**RESPONSE TO WDNR COMMENTS LETTER
MIRRO PLANT NO. 9 (FORMER)
1512 WASHINGTON STREET, MANITOWOC, WISCONSIN
WDNR BRRTS NO. 02-36-545108 | FID NO. 436033730**

Ramboll Americas Engineering Solutions, Inc. (Ramboll), on behalf of Newell Operating Company (NOC), has prepared this *Response to WDNR Comments* letter (the "RTC letter") to address the comments provided by the Wisconsin Department of Natural Resources (WDNR) in their April 3, 2024, *Review of the Site Investigation – Additional Investigation Needed* letter (the "WDNR letter").

**WDHS RECOMMENDED GROUNDWATER CRITERIA
 PFAS IN SHALLOW GROUNDWATER
 JULY 2023**

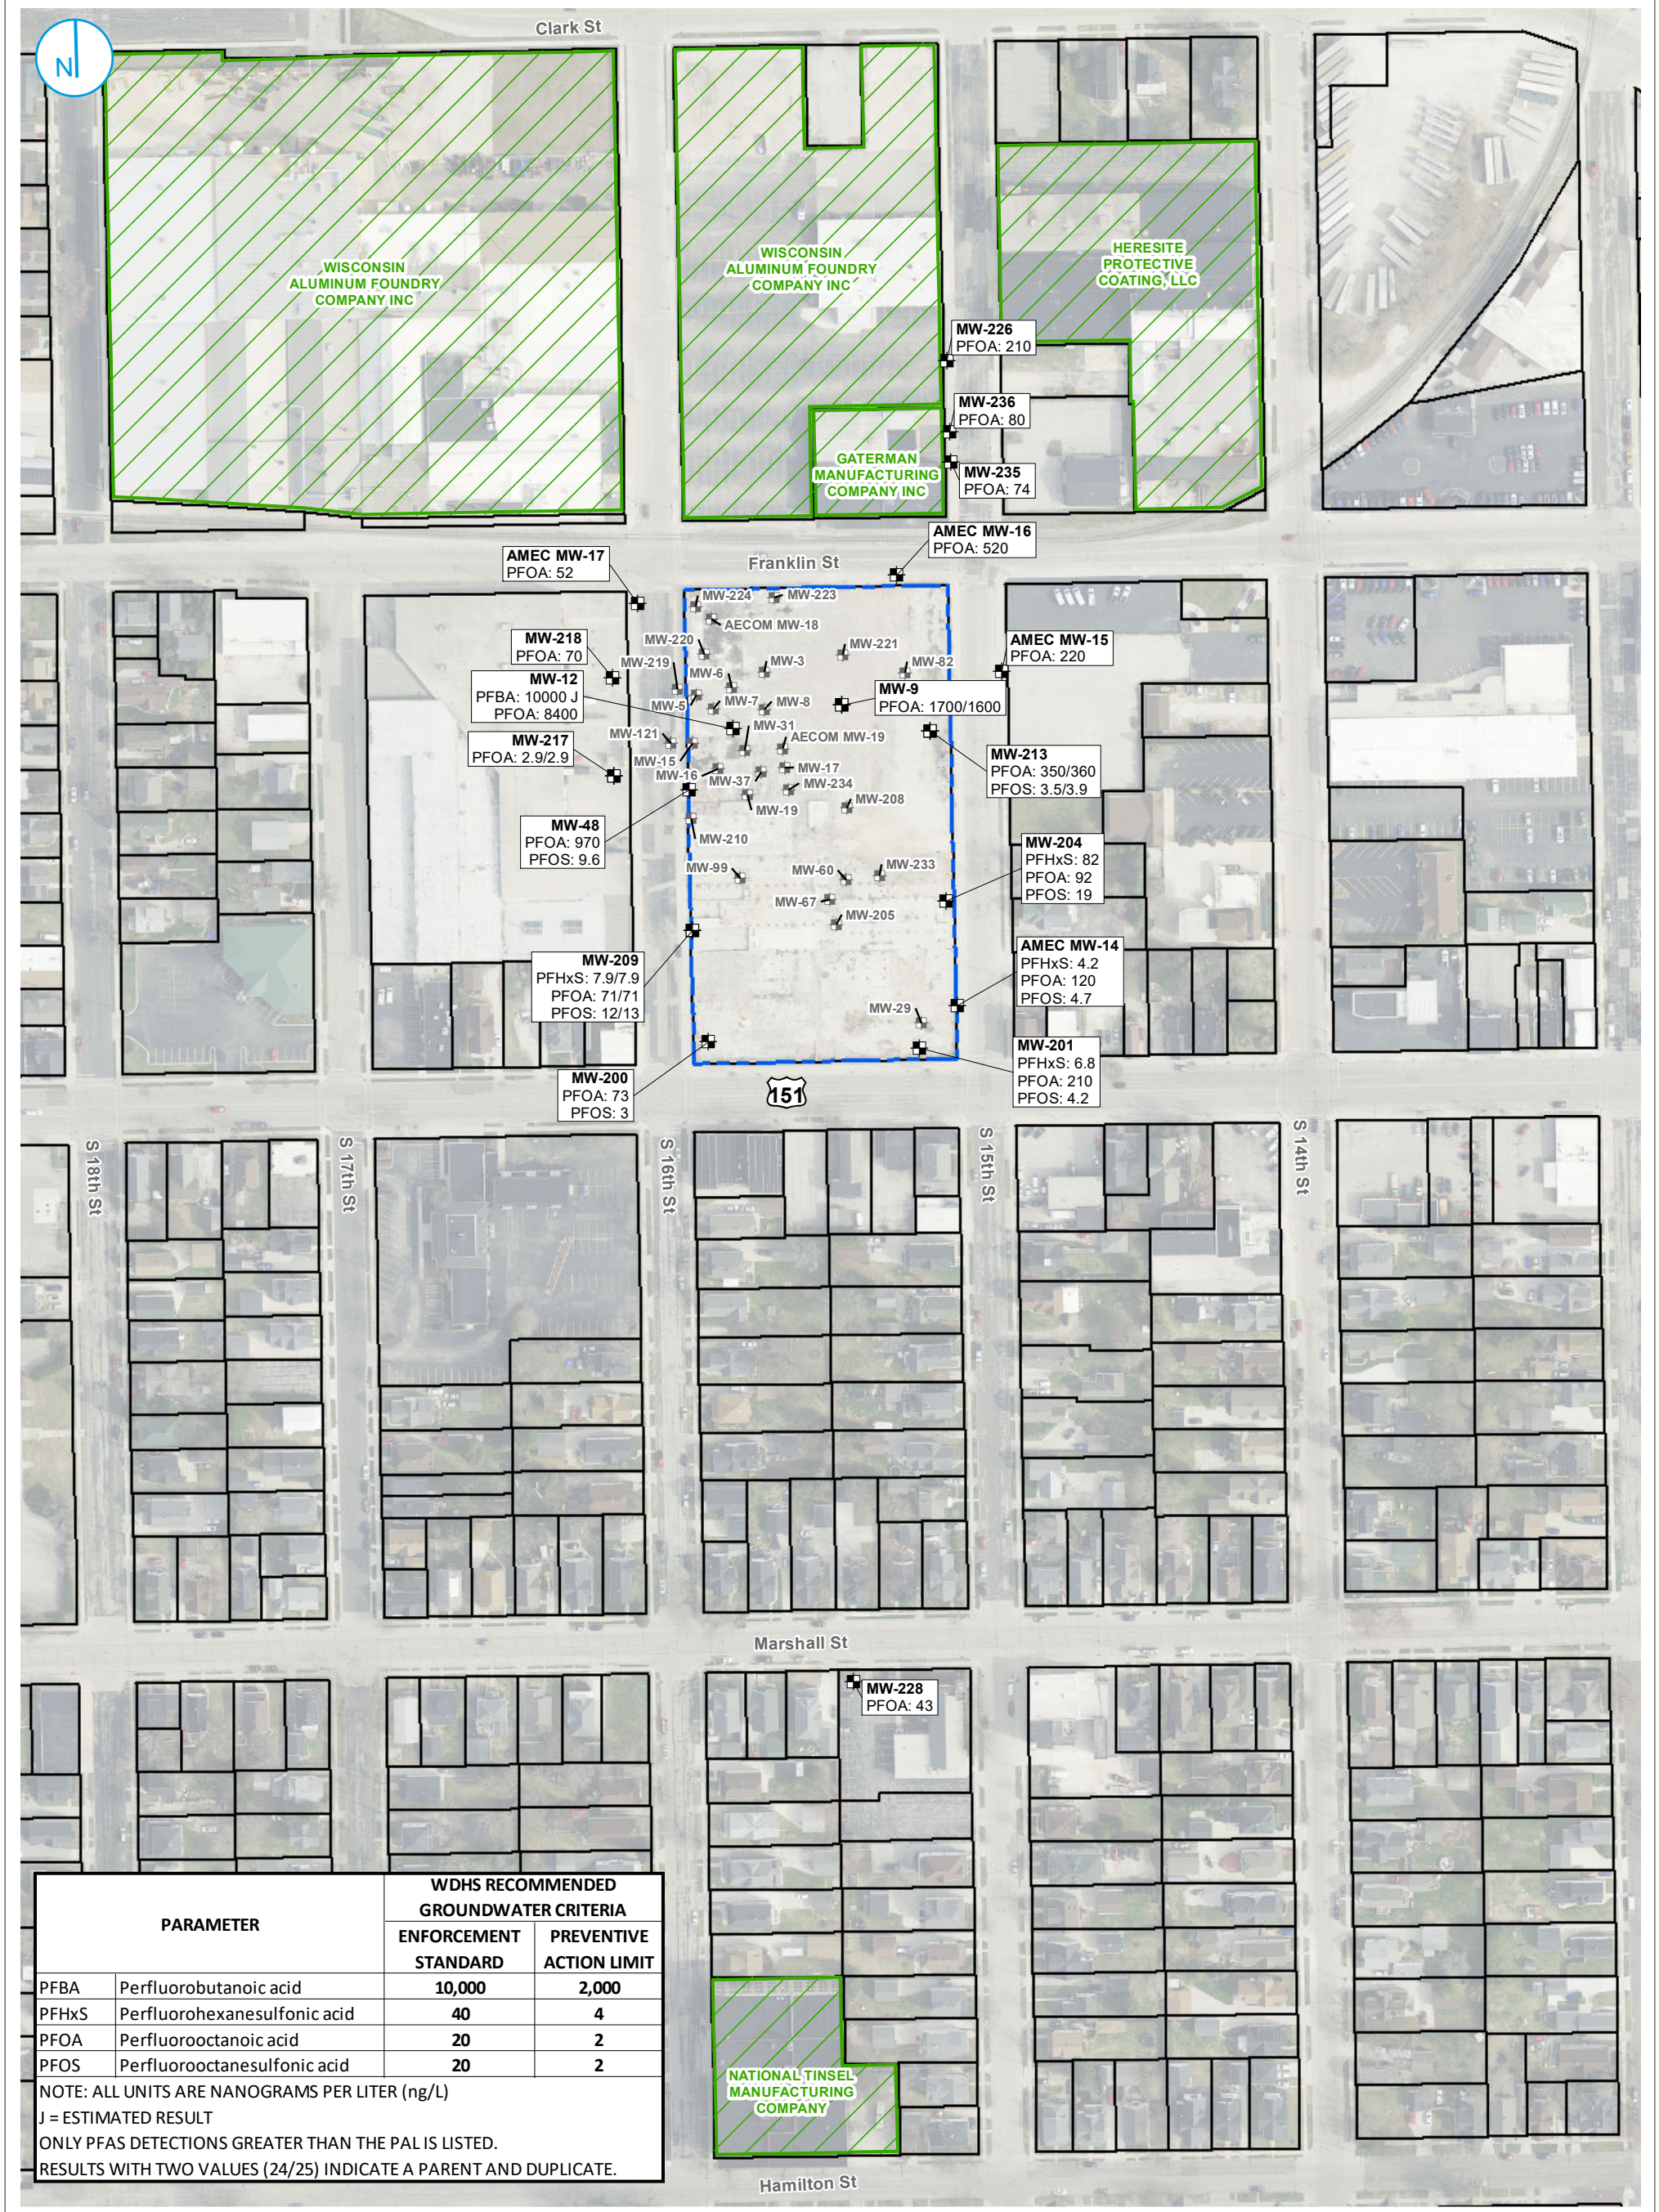
- *PFAS [per- and polyfluoroalkyl substances]: Additional PFAS investigation is needed since the extent of PFAS in groundwater is not defined based on the Wisconsin Department of Health Services (DHS) recommended standards. DNR indicated additional PFAS investigation was needed in the Review of the Site Investigation – Additional Investigation Needed letter dated April 6, 2022, and the installation of two additional off-site monitoring wells and one year of monitoring did not alter that previous determination.*

Based on the PFAS groundwater sampling data collected from the former Mirro Plant No. 9 monitoring well network, PFAS in groundwater have been delineated on-site and concentrations are stable. As discussed in the 2024 *Site Investigation Report Addendum*, Ramboll acknowledges detections of PFAS above proposed WDHS recommended standards in groundwater samples collected both on- and off-site; however, PFAS in groundwater above proposed WDHS recommended standards are found in both hydrogeologically upgradient (MW-226 and MW-228) and side-gradient (AMEC MW-14, AMEC MW-15, AMEC MW-17, MW-217, and MW-218) monitoring wells, which demonstrates that off-site upgradient PFAS sources exist.

Notably, potential off-site PFAS sources are located near the site in the upgradient, side-gradient and downgradient directions (e.g., National Tinsel Manufacturing Company; Wisconsin Aluminum Foundry Company, Inc.; Gaterman Manufacturing Company, Inc.; and Heresite Protective Coatings, LLC; among others) and could be causing or contributing to the low PFAS concentrations detected downgradient of the site (Attachment A). This is evidenced by the varying PFAS concentrations in monitoring wells MW-226, MW-235, and MW-236. Given the presence of off-site upgradient, sidegradient, and downgradient PFAS sources; documented PFAS concentrations in upgradient, side-gradient and downgradient monitoring wells; and the absence of promulgated WAC NR 141 groundwater standards, defining the concentration of PFAS in groundwater off-site to the proposed WDHS recommended standards is not practicable.

Ramboll has defined the extent of PFAS impacted groundwater on-site. And for the reasons stated above, Ramboll recommends that no additional off-site groundwater investigation activities be required at this time.
